NORTH LONDON WASTE AUTHORITY
NORTH LONDON HEAT AND
POWER PROJECT
EN10071

STATEMENT OF COMMON GROUND:
LONDON BOROUGH OF ENFIELD

AD03 . 04

June 2016

Figure 1: Location of SuDS surface feature

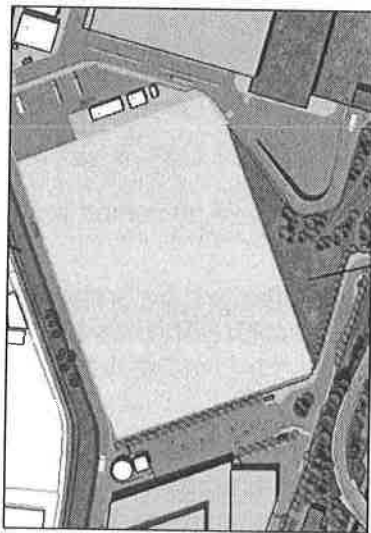
3.25.2 It is agreed that due to the nature of the waste management use and the requirement to comply with pollution prevention requirements (e.g. the Environment Agency's Fire Prevention Plan) there is limited opportunity for surface SuDs features at the Application Site. The use of permeable paving in the staff and visitor parking area is agreed, as is the approach to green and brown roofs as set out in the Application. A piped and tanked drainage system with oil interceptors is agreed as an appropriate approach to surface water management. It is also agreed that a surface SuDs feature will be provided in the landscape area to the east of the existing EfW, shown in Figure 1. This commitment has been added to the updated Environmental Commitments and Mitigation Schedule (AD06.03) submitted at Deadline 6.
